CHARTER TOWNSHIP OF GARFIELD PLANNING COMMISSION MEETING

Wednesday, June 8, 2022 at 7:00 pm
Garfield Township Hall
3848 Veterans Drive
Traverse City, MI 49684
Ph: (231) 941-1620

Charter Township of Garfield Planning Department Report No. 2022-47		
Prepared:	June 1, 2022	Pages: 10
Meeting:	June 8, 2022 Planning Commission	Attachments: <input checked="" type="checkbox"/>
Subject:	Life Story Crematorium I-G Conditional Rezoning – Findings of Fact	
File No.	Z-2022-01	Parcel No. 05-024-019-30
Owner:	LeVon M. Seavolt “Vaughn”	
Applicant:	LMS Property, LLC

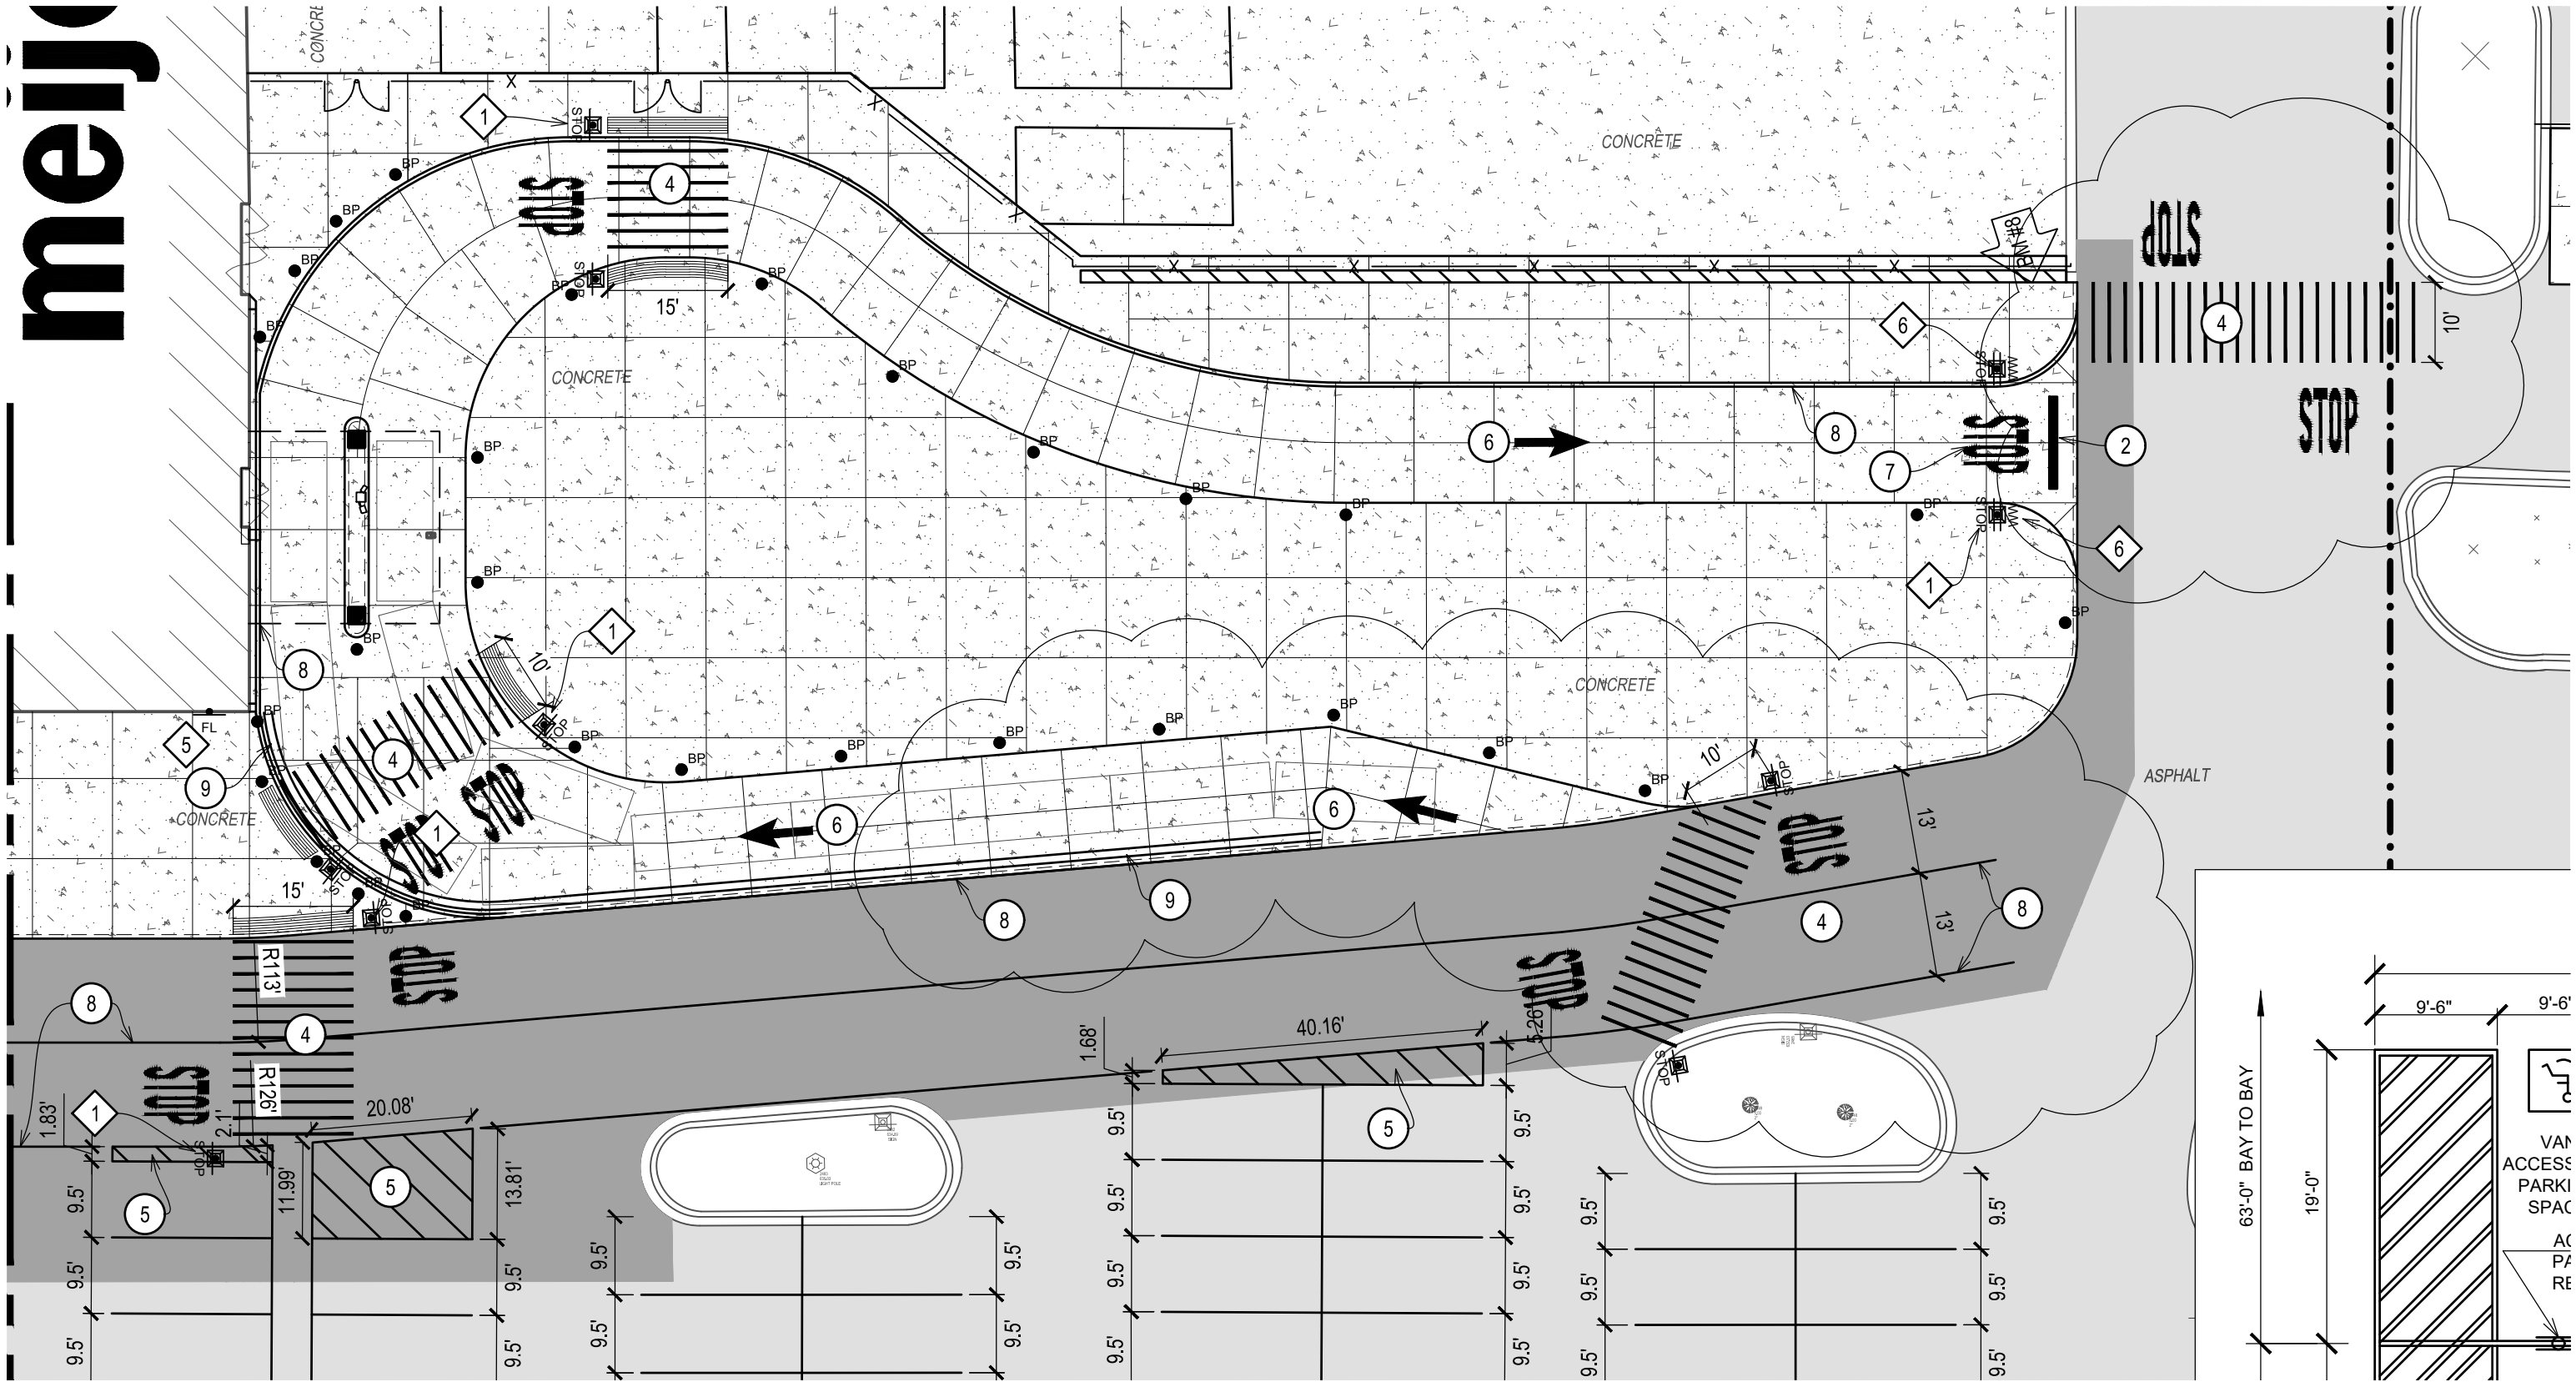
I reviewed the Garfield Township Zoning Ordinance Article 7 and the proposed drive-thru layout. I found that the vehicle length needed to be increased from 19 feet to 20 feet per vehicle. As a result of this, the overall length of the drive through lane would be extended to the north by 10 feet. Also, the interior drive-thru lane would need to be extended to the west toward the store to allow the vehicle to complete their turn to be parallel to the service window. With these modifications, stacking (queuing) space for 12 vehicles can be achieved. Also, at the service position for both drive-thru lanes, the front of the vehicle should be approximately seven feet from the service window position. This is the industry standard distance from the front of the average vehicle to the driver position.

There are some bump posts to guide vehicles along the inside of the drive-thru lane(s) to the pedestrian crossing. My recommendation is to continue the bump post at the same spacing along the entire inside of the drive-thru entry and exit back to the main interior circulation aisle. This will help delineate the vehicle space from the interior area.

The proposed drive aisle pedestrian crossing to the north of the Pharmacy drive-thru entrance should be moved slightly south so that the vehicles turning onto the main circulation aisle will have a clearer view of the STOP sign for the crossing.
